**SPADINA MUSEUM
GARAGE
REHABILITATION**
285 SPADINA ROAD TORONTO, ON

MECHANICAL TENDER ADDENDUM M-01

October 3, 2023

PROJECT: Spadina Museum Garage Rehabilitation and Site Accessibility
LOCATION: 285 Spadina Road, Toronto, ON M5R 2V5
Client Project #: A22048
M4S Project #: 22626

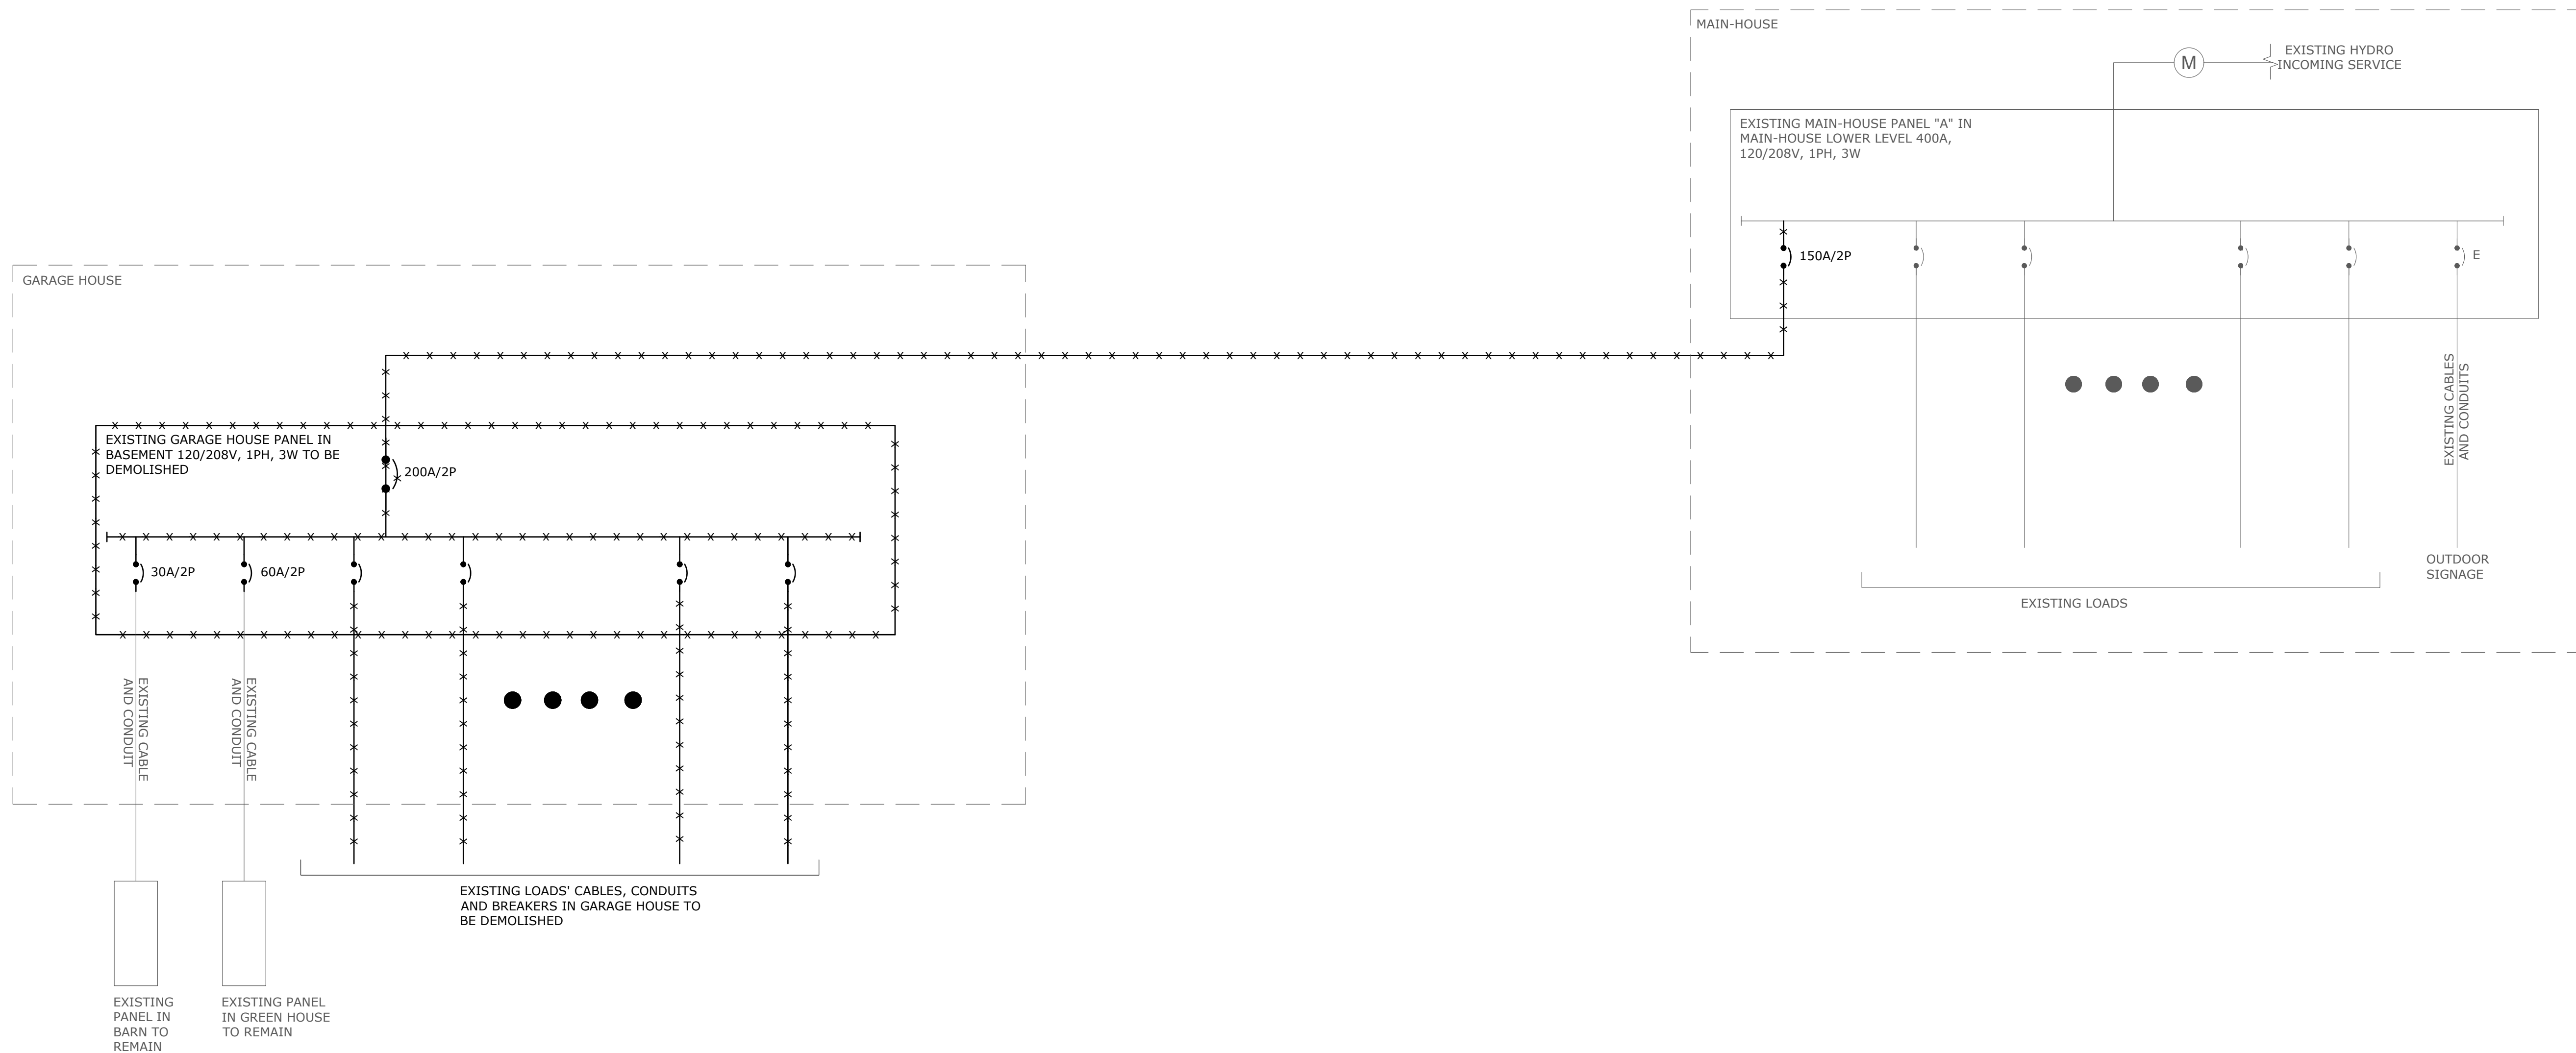
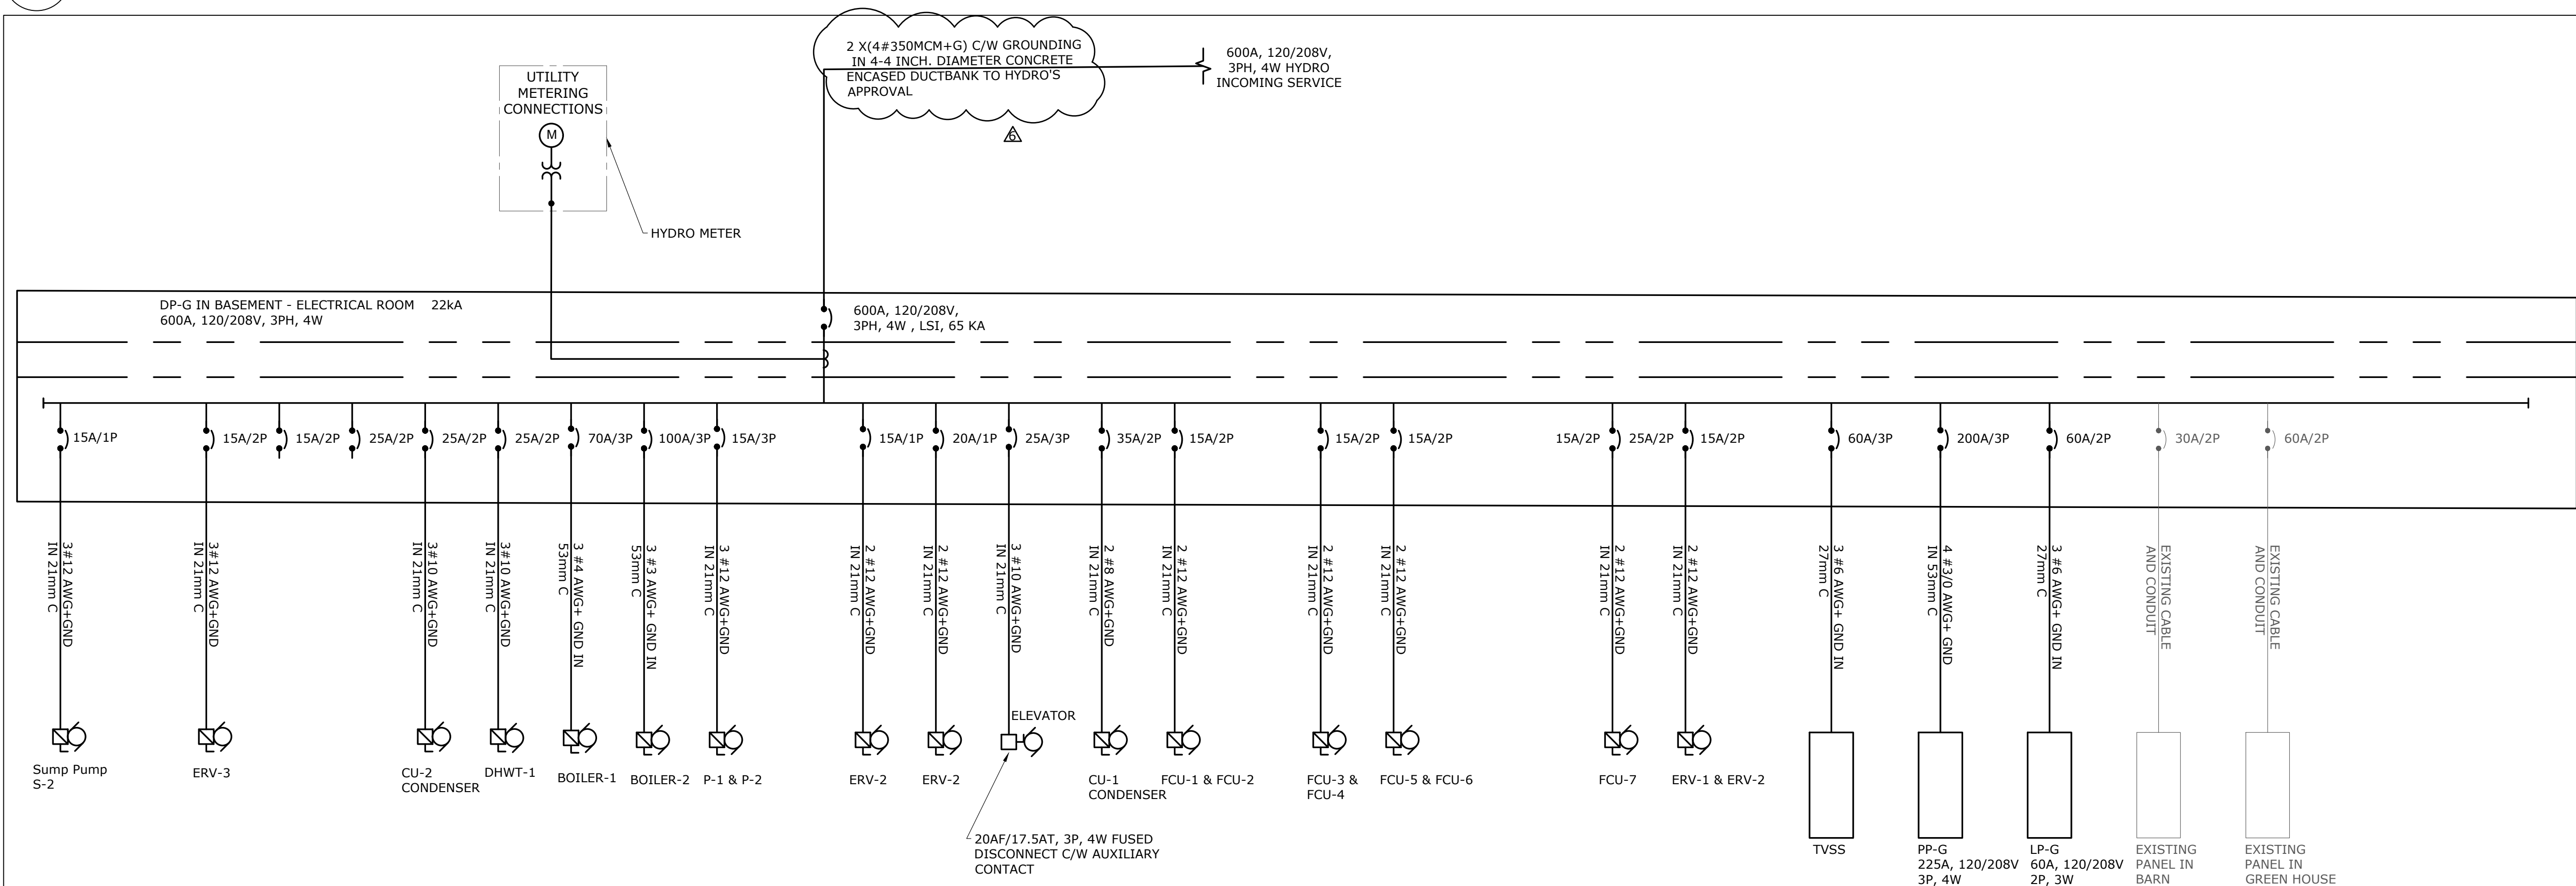
- Detail 2/E-300
 - Layout of electrical room revised; panel locations modified.
- **Dwg. E-301**
 - Detail 2/E-301
 - Reference note #10 added.
- **Dwg. E-302**
 - Detail 2/E-302
 - Reference note #1 added.
 - Heat detector added in Janitor room.
- **Dwg. E-900**
 - Detail 2/E-900
 - Secondary conductor specified, c/w switchboard and Hydro metering.
